November 4, 1999

**Re: Addendum No. 1 to Removal Action Work Plan -
Upper ½-Mile Reach of the Housatonic River
General Electric Company, Pittsfield, Massachusetts**

This Addendum No. 1 presents information associated with construction and restoration activities in the Upper ½-Mile Reach of Housatonic River adjacent to the Lyman Street Area (as defined in the Consent Decree). This information is presented on two attached figures -- Figure 4-4 and Figure 7-1D. The first figure (Figure 4-4) has been revised to identify the lateral limits of excavation associated with the installation of barrier sheeting at the Lyman Street Area and the location of several removal/restoration cross-sections within the excavation area. In addition, as depicted on Figure 4-4, a continuous layer of rip-rap along the toe-of-slope between polygons SL0229 and SL0170 has been added. The second figure (Figure 7-1D) depicts cross-sections (Sections V-V' through AA-AA') indicated on Figure 4-4 and identifies the limits of excavation and the proposed restoration activities for those areas.

**FIGURE
4-4**

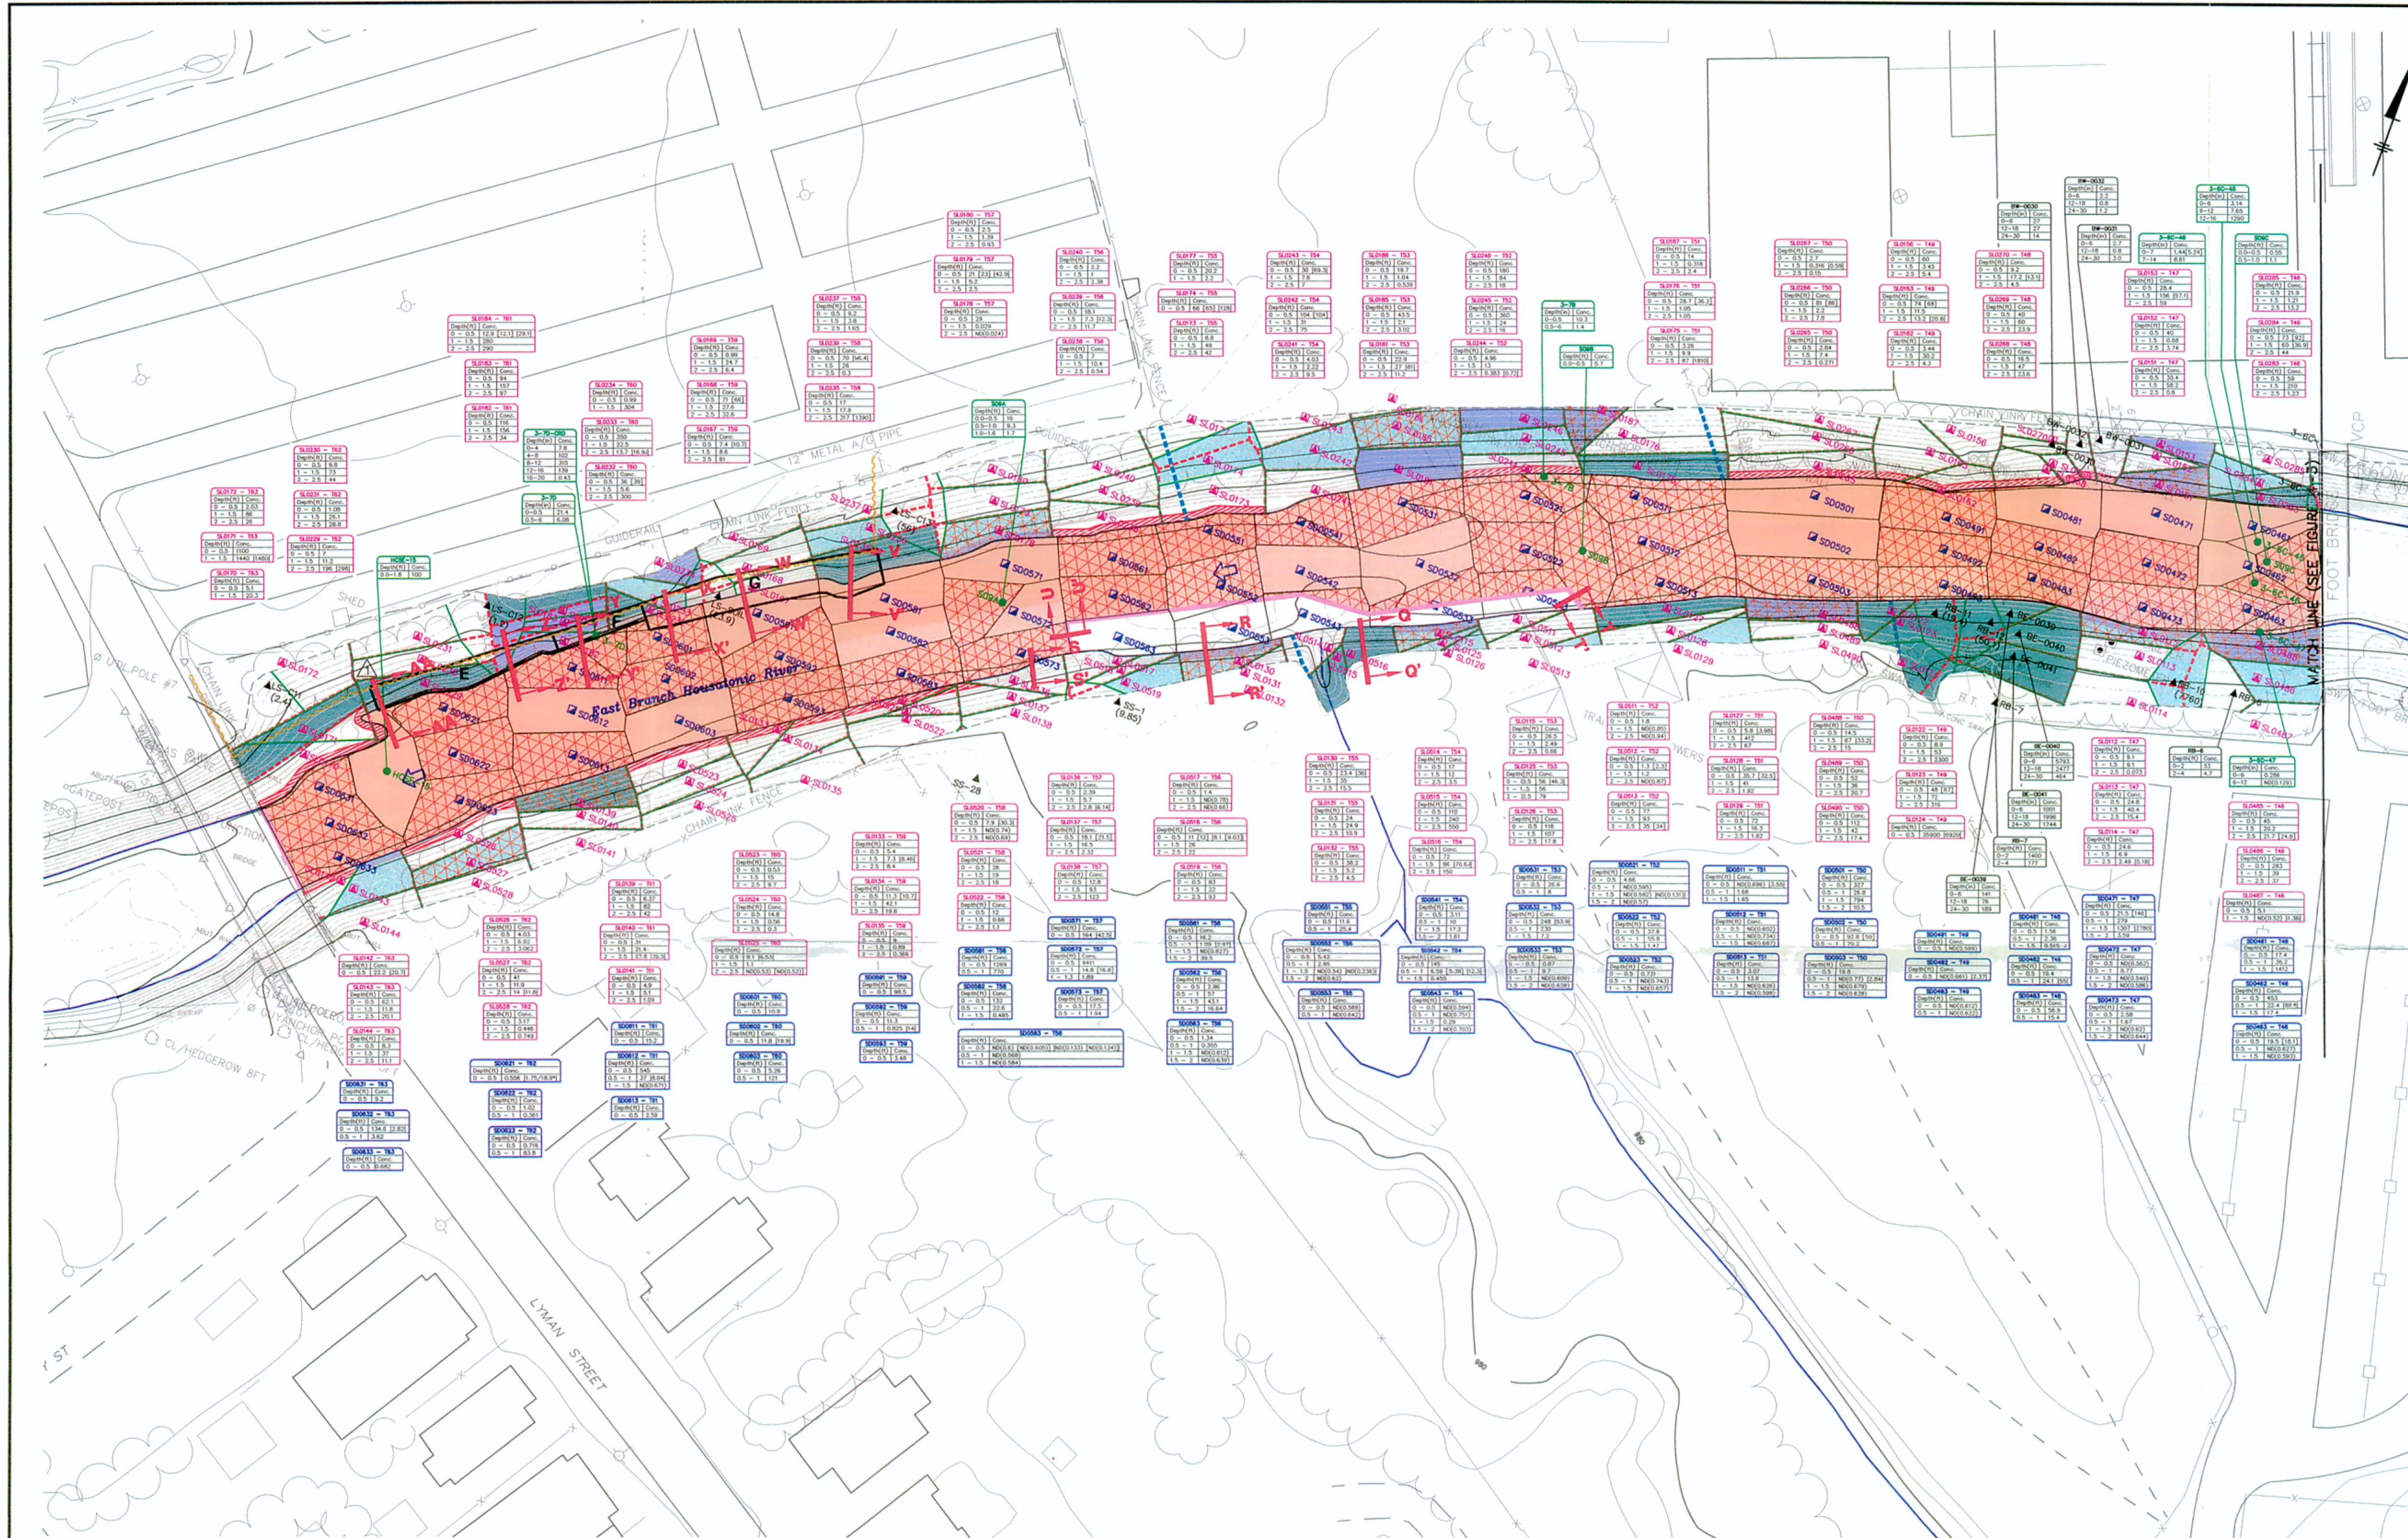
No.	Date	Revisions
1	11/4/99	ADDENDUM No. 1 - LYMAN STREET CROSS SECTIONS

LYMAN STREET SOURCE CONTROL EXCAVATION	
SECTION	PROPOSED ELEVATION OF FINAL EXCAVATION
E	972.5
F	969.5
G	967.5
